PHAP15-00037

Date:	October 12, 2015
Application Type:	Certificate of Appropriateness
Property Owner:	Maria, Lilia, and Andres Favela
Representative:	Andres Favela
Legal Description:	Being 1 Mundy Heights 3 To 6, City of El Paso, El Paso County, Texas
Historic District:	Sunset Heights
Location:	209 Lawton Street
Representative District:	#8
Existing Zoning:	R-4/H (Residential/Historic)
Year Built:	1928
Historic Status:	Contributing
Request:	Certificate of Appropriateness for the construction of a secondary garage and the removal and replacement of windows after-the-fact
Application Filed:	9/3/2015
45 Day Expiration:	10/18/2015

ITEM #1

SITE PLAN

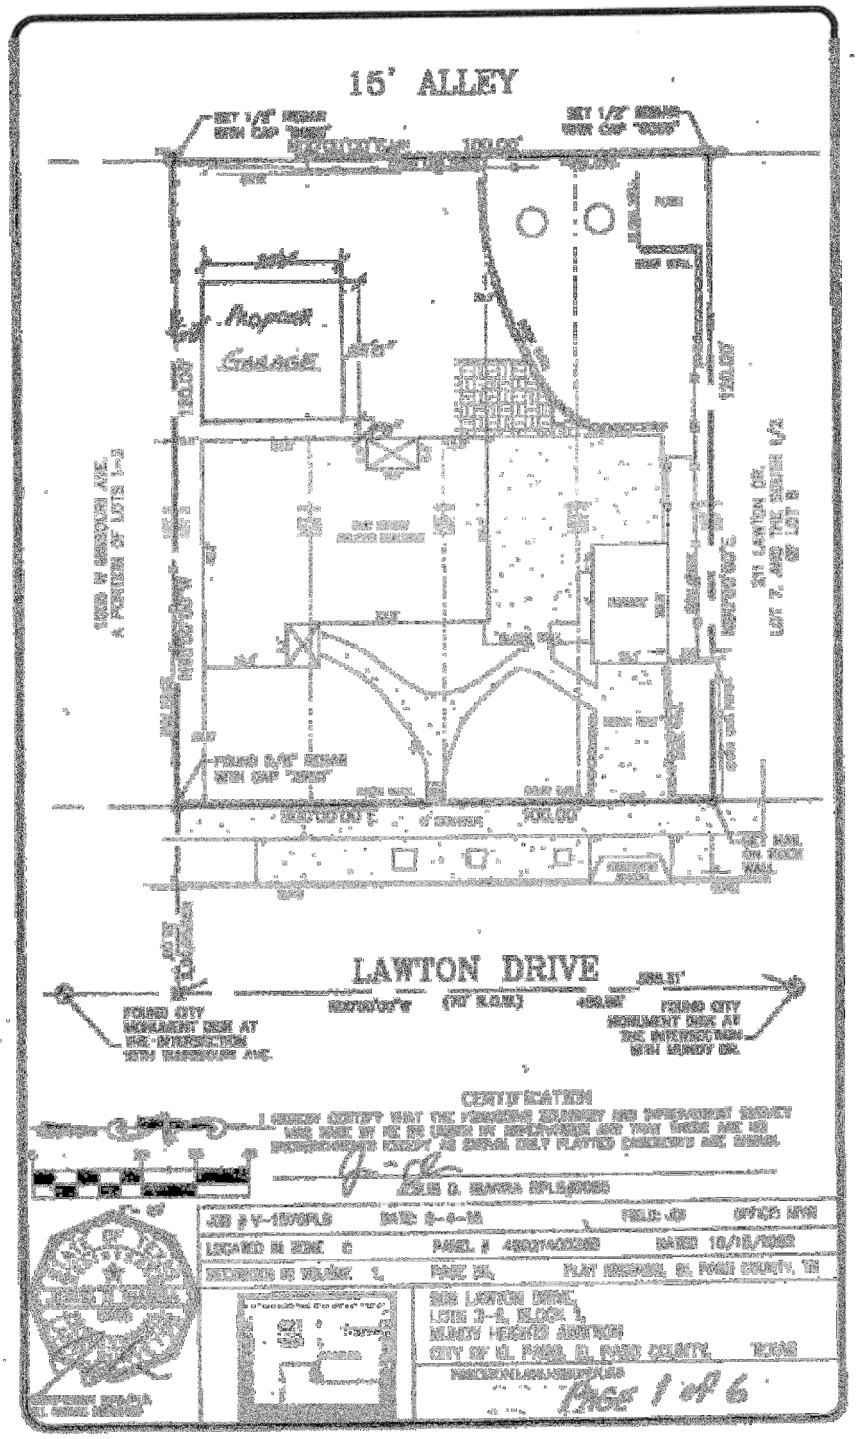
The modifications are that the garage be moved back one foot so that it is five feet away from the main structure; that the replacement windows be removed and replaced with windows that replicate the original windows in type, style, operation, configuration and finish; that no permits for the new construction be issued until the replacement windows have been installed and are in compliance; and that the new windows be installed within ninety (90) days.
